SERVICE BULLETIN MAINTENANCE OF WAY EQUIPMENT

DATE: 5-25-2016 **BULLETIN NO:** 16-002

TITLE: TAMPER WORKHEAD VIBRATOR MOTOR ROTATION

PRODUCT SERIES / MODEL: All Mark IV Tampers, Mark VI Tampers and Drone Tampers

FIGURE 1
WORKHEAD VIBRATOR ROTATION

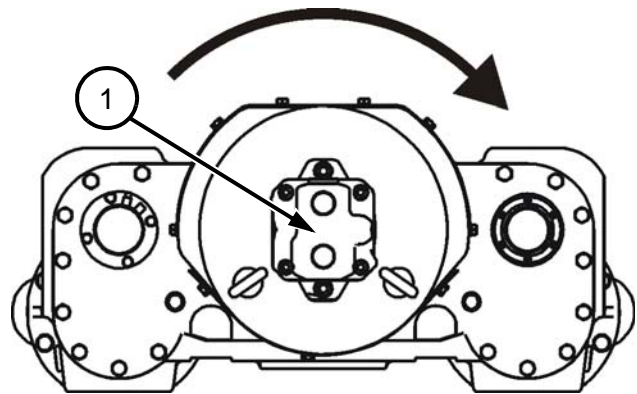
SUMMARY: If the hydraulic piping to a workhead vibrator motor has been disconnected for any reason, the hydraulic lines may have been re-connected incorrectly to the motor ports causing the vibrator motor to rotate counter-clockwise instead of clockwise. If a vibrator motor is rotating counter-clockwise, the upper portion of the workhead vibrator will not be properly lubricated leading to premature vibrator failure.

CHECKING WORKHEAD VIBRATOR MOTOR ROTATION - See Figure 1

1. Enable the workheads on the machine. Start the workhead vibrator motors.
2. Check the workhead vibrators for clockwise rotation when viewed from the top of the workhead vibrator.
 - a. If the vibrators are rotating clockwise, the rotation is correct and no further action is required.
 - b. If one or more vibrators are rotating counter-clockwise, the rotation is incorrect and the rotation direction must be changed. See Changing Workhead Vibrator Motor Rotation.

CHANGING WORKHEAD VIBRATOR MOTOR ROTATION - See Figure 1

1. Stop the workhead vibrator motors. Stop the engine. Depressurize the hydraulic system.
2. Disconnect the hydraulic lines to the vibrator motor (1) that was rotating counter-clockwise. Be sure to catch all hydraulic fluid in a leak proof container.
3. Re-connect the hydraulic line that was originally in Port "A" of the motor (1) to Port "B" of the motor. Re-connect the hydraulic line that was originally in Port "B" of the motor (1) to Port "A" of the motor. Tighten all hydraulic lines securely.
4. Repeat Checking Workhead Vibrator Motor Rotation Procedure to verify the workhead vibrator motor rotation is clockwise.
